SUBJECT: Calvert Cliffs Nuclear Power Plant
Unit Nos. 1 & 2; Docket Nos. 50-317 & 50-318
Response to Request for Additional Information Regarding Interim Inspection Requirements for Reactor Pressure Vessel Head (TAC Nos. MB7752 and MB7753)

RESPONSE TO NRC REQUEST FOR ADDITIONAL INFORMATION

FIGURE 1
CEDM Nozzle Node Numbering Scheme

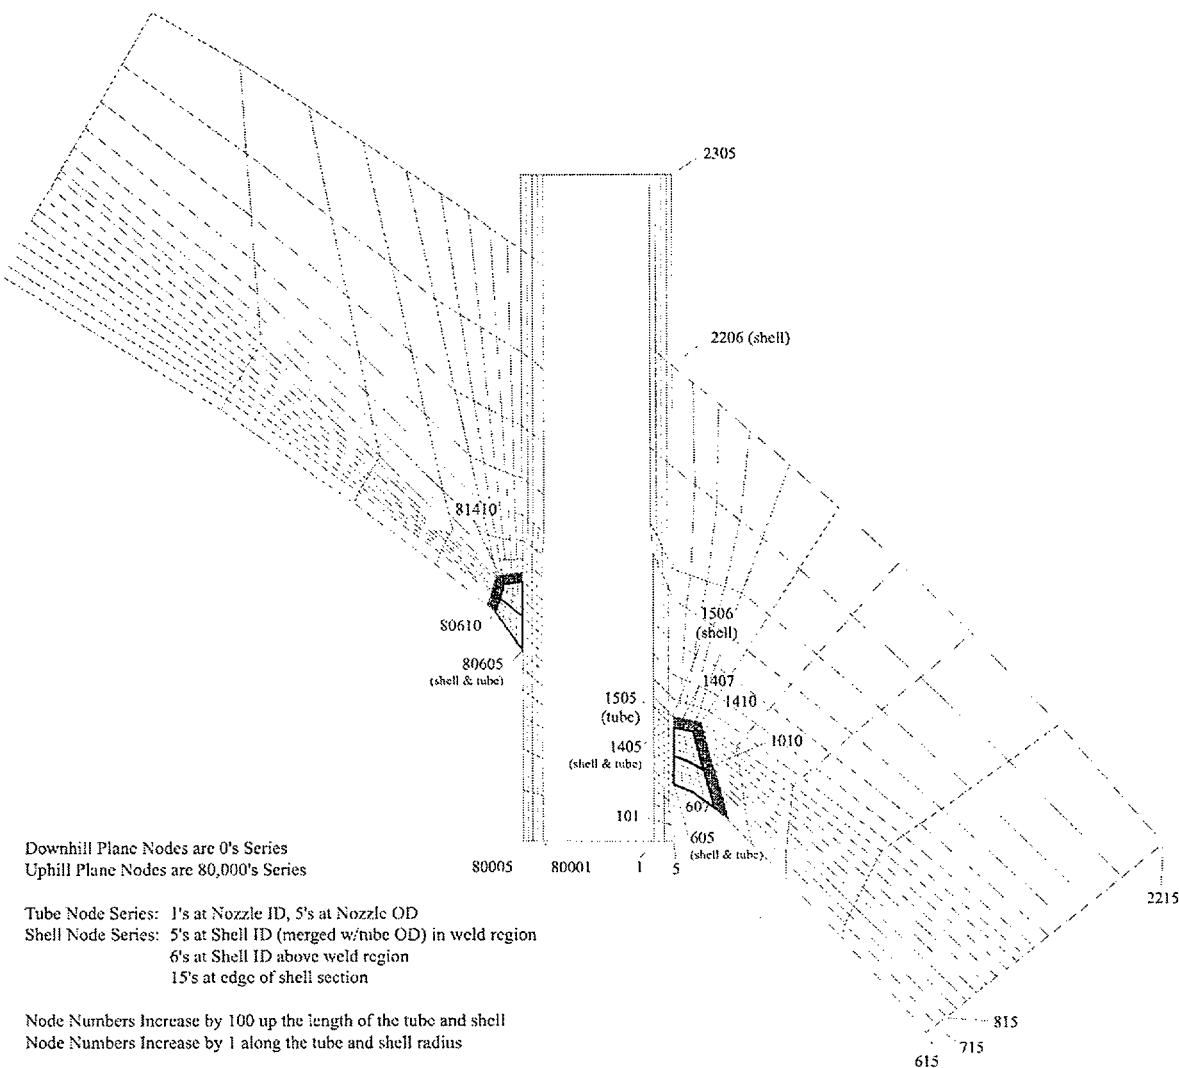
Please provide a tabular listing of the maximum operating stress (across the cross-section) from the top of the J-groove weld to 2 inches above the weld. How does the yield strength of the nozzle material used in the calculations compare to the strength of the Calvert Cliffs nozzles, and what impact does the yield strength difference have on the calculated residual stresses?

A tabular listing is provided as Enclosure (1). This enclosure describes the axial and hoop stresses at the nodes of the finite element model used to produce the color figures that were provided in the first set of request for additional information questions. For reference in correlating the node numbers to their position in the model, please use the attached Figure 1, which shows the node-numbering scheme used in the models. In general, nodes increase from 1 to 5 through the nozzle wall from inside diameter (ID) to outside diameter (OD), nodes increase by 100's axially, and increase by 10000's circumferentially. The tabulation provides the axial and hoop stresses at the ID and OD surfaces. The stresses are reported only at nodes, so the stress at the 2-inch elevation is not provided. Instead, the stress at the node closest to the 2-inch elevation is provided.

FIGURE 2

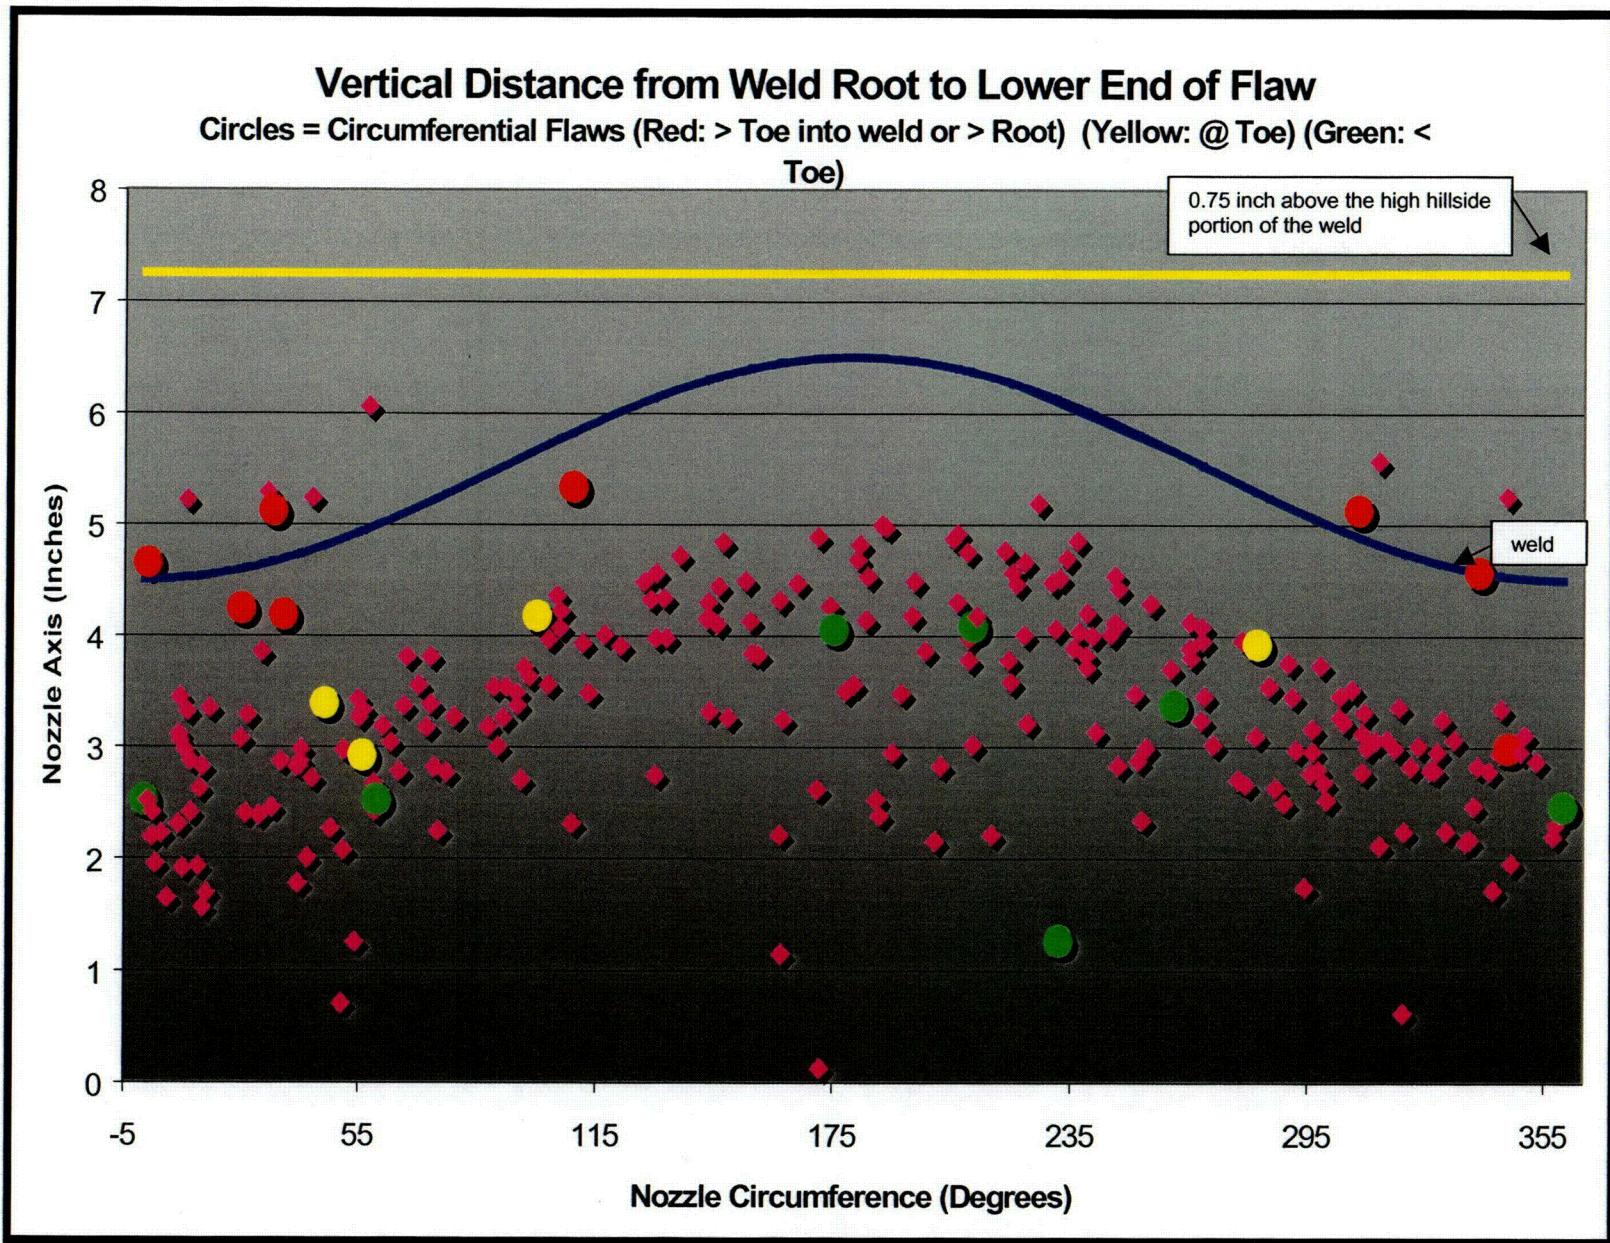
As stated in the response, the inspection contractor's evaluation of 260 cracks in reactor pressure vessel penetrations at other plants showed that all cracks were found located below 0.75 inch above the weld. Are the data evaluated inclusive of all data from all inspections by all vendors? Based on the data evaluated, has any analysis been performed to conclude that all 260 indications would still have been detected even if the scope of examination had been only 0.75 inch above the weld? What does industry experience with outside diameter primary water-stress-corrosion cracking (PWSCC) in vessel head penetration (VHP) nozzles indicate about the likelihood for cracking in the region of the VHP nozzle more than 0.75 inch above the top of the J-groove weld?

The inspection contractor's evaluation of 260 cracks in VHP nozzles at other plants was performed on data available only to the contractor. No analysis was performed on data from plants inspected by other contractors. Therefore, the data evaluated were not inclusive of all data from all inspections by all vendors.

Since all 260 previously identified cracks were located below 0.75 inches above the weld, we conclude, with high confidence, that all 260 indications would have been detected with an examination scope up to 0.75 inches above the weld. However, no analysis has been performed since such an analysis would require re-evaluation of the entire inspection data sets from previously inspected plants. The re-evaluation would need to be performed in a double blind experiment with modifications to the raw data to limit coverage to 0.75 inch above the weld. It is difficult to get operating plants' permission to have third parties independently modify, then re-analyze their inspection data. Calvert Cliffs has no plans to perform this analysis.

Industry experience with outside diameter PWSCC in VHP nozzles is indicated on the attached figure "Vertical Distance from Weld Root to Lower End of Flaw" (Figure 2), which shows the approximate location of circumferential cracks identified in previous inspections by this inspection contractor.
